**JOINT ARCHITECTURAL BOARD/PLAN COMMISSION AGENDA**  
**MONDAY, FEBRUARY 19, 2018**  
**7:00 PM**  
**BOARD ROOM**  
**MUNICIPAL BUILDING, 210 COTTONWOOD AVE.**

Re: Village of Hartland  
MW Storage Building – Plan Review Letter

The Village of Hartland's Staff as well as Ruekert & Mielke, Inc. have reviewed your site plan submittal. The submittal included the following: sheets T1.0, SP1.0, A1.0, A2.0, LS1.0, D1.0, D2.0 (all dated 1/26/18); L1.0 (dated 1/24/18); and 3 site plan sheets (dated 1/25/18). In addition, a storm water management report prepared by Lake Country Engineering, Inc. dated January 25, 2018 was submitted. We are providing the following comments as guidance and direction for your design staff in preparation for the next Plan Commission meeting and for final documents. **Please respond to the comments below, in writing, with your next submittal.** You should plan to attend the Plan Commission meeting on February 19, 2018 at 7:00 pm to present your project plans.

**EXISTING CONDITIONS PLAN**  
MWS WAREHOUSE, HAV 0732.996.020  
OLIVER CONSTRUCTION LOT 3 C.S.M. 6961  
SE 1/4 S.3., T.7N., R.18E., VILLAGE OF HARLAND.

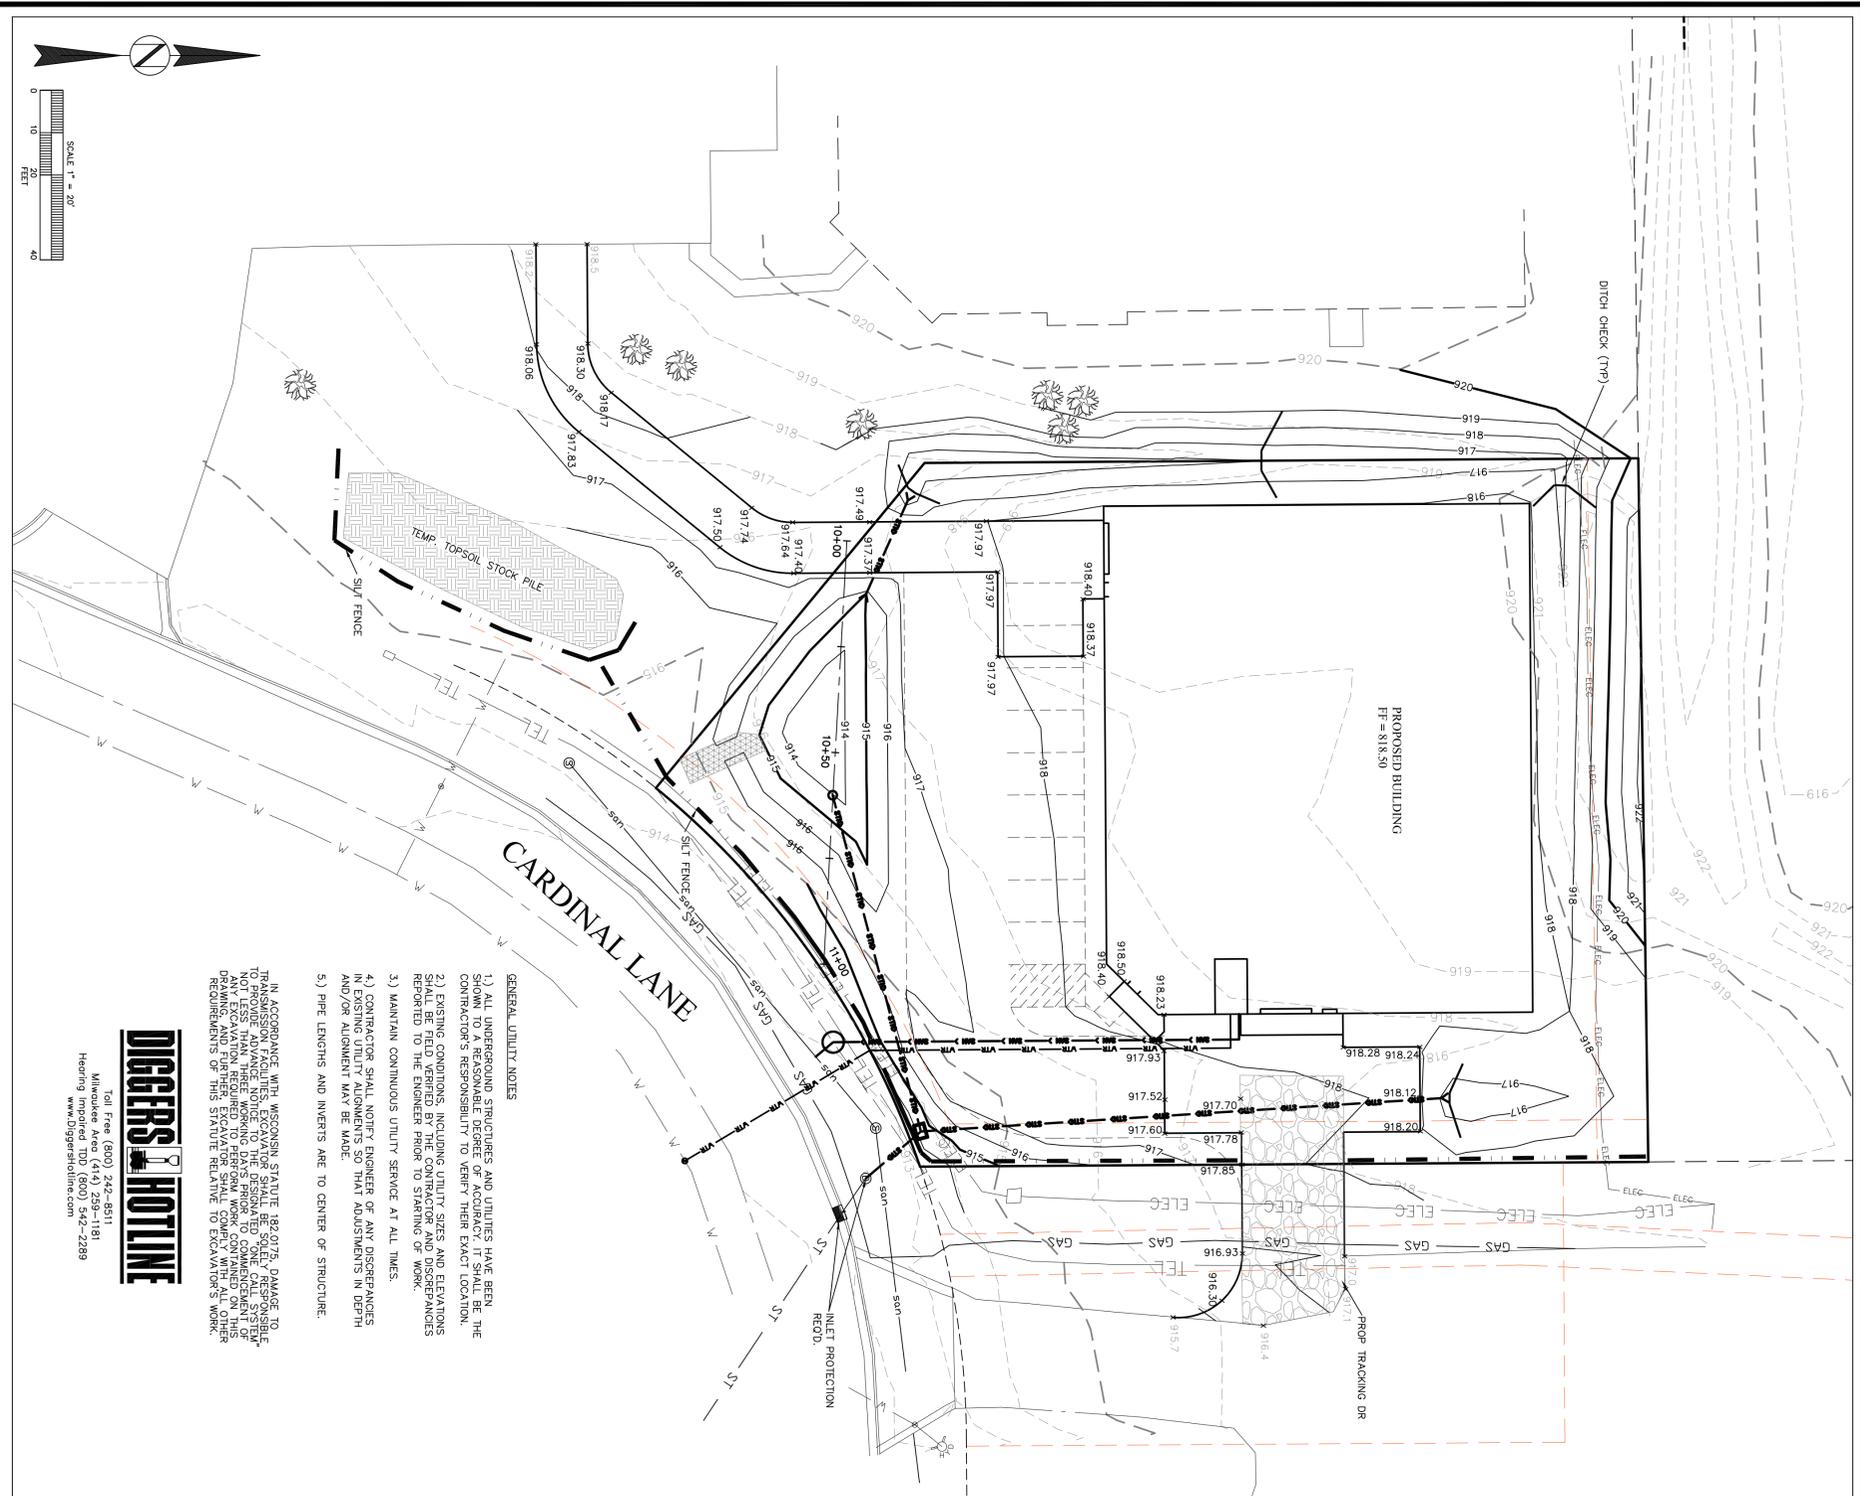
1. There are two borings referred to as Boring 3. Correct on this sheet and elsewhere in the plans and storm water management plan.

**Exterior Lighting – Sheet L1.0**

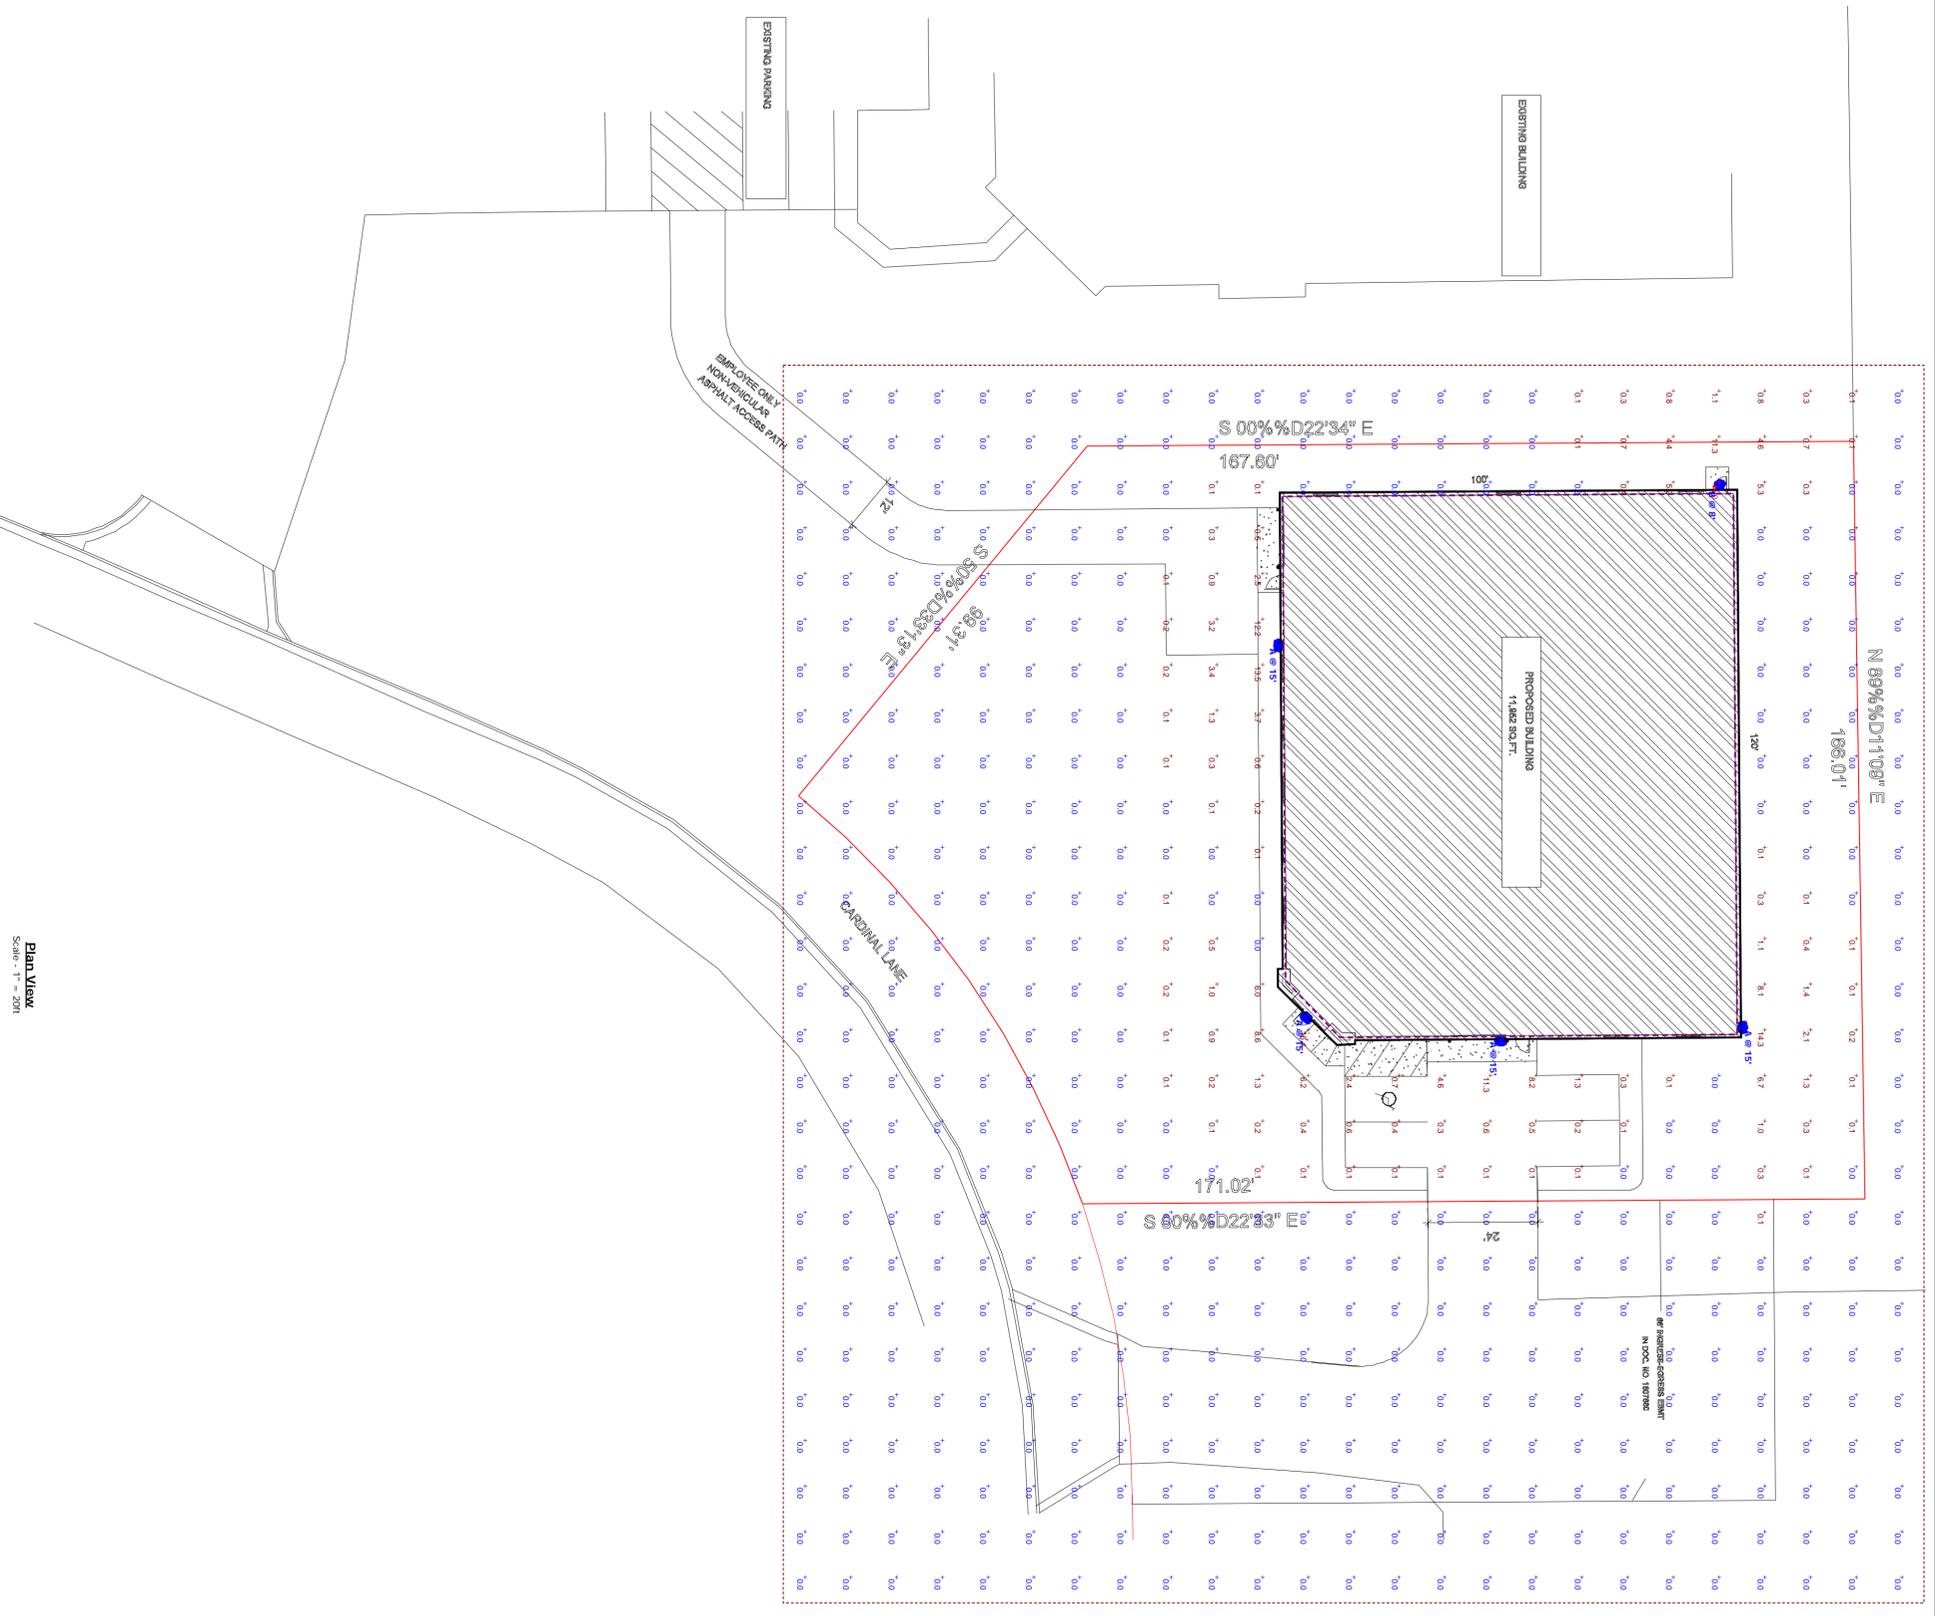
1. Provide cutoff from the northwesterly exterior light to eliminate spill over light. 0.5-foot candles maximum allowed at property line. Update photometrics plan.
